Access Compliance Report Public Rights-of-Way (Curb Ramps)

Main Street: AIROSO_ST Cross Street: N/A Location: NE

ADA ID: RPRK211201143407 Ramp Type: Type 3 - Combination 1 Initial Pass/Fail: Fail Overall Compliance: No Severity Score: 30

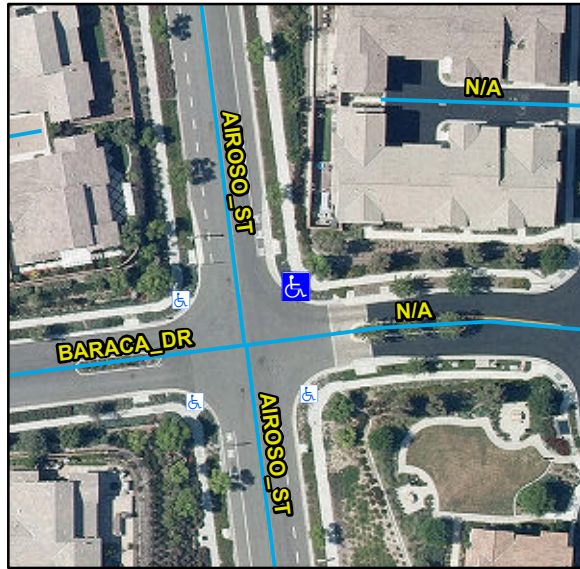
R304.2.2, R304.3.2, R304.5.3, STD 1115

Compliance	Description	Data	Compliance	Description	Data
N/A	Ramp Length LT (in)	118	N/A	Ramp Length RT (in)	120
Yes	Ramp Width LT (in)	71	Yes	Ramp Width RT (in)	58
No	Ramp Run Slope LT (%)	12.5	Yes	Ramp Run Slope RT (%)	2.1
No	Ramp Cross Slope LT (%)	2.9	Yes	Ramp Cross Slope RT (%)	1.5
N/A	Ramp Length (in)	148	N/A	Flare Type LT	
Yes	Ramp Width (in)	60			N/A
Yes	Ramp Run Slope (%)	5	N/A	Flare Slope LT (%)	N/A
Yes	Ramp Cross Slope (%)	1.3	N/A	Flare Traversable LT	N/A
N/A	Landing Present	N/A	N/A	Flare Type RT	
N/A	Landing Length (in)	N/A			N/A
N/A	Landing Width (in)	N/A	N/A	Flare Slope RT (%)	N/A
N/A	Landing Run Slope (%)	N/A	N/A	Flare Traversable RT	N/A
N/A	Landing Cross Slope (%)	N/A	N/A	DWS Provided	N/A
N/A	Landing Movement Obstructed?	N/A	N/A	DWS Contrast	N/A
	Landing Movement Type	N/A	N/A	DWS Length (in)	N/A
N/A	Landing Shared	N/A	N/A	DWS Full Width	N/A
N/A	Clear Space	Yes		DWS Offset Type	N/A
N/A	Clear Space To Crosswalk (in)	N/A	N/A	DWS Offset Left (in)	N/A

Remove & Replace Curb Ramp With Two New Directional Ramps or Equivalent.
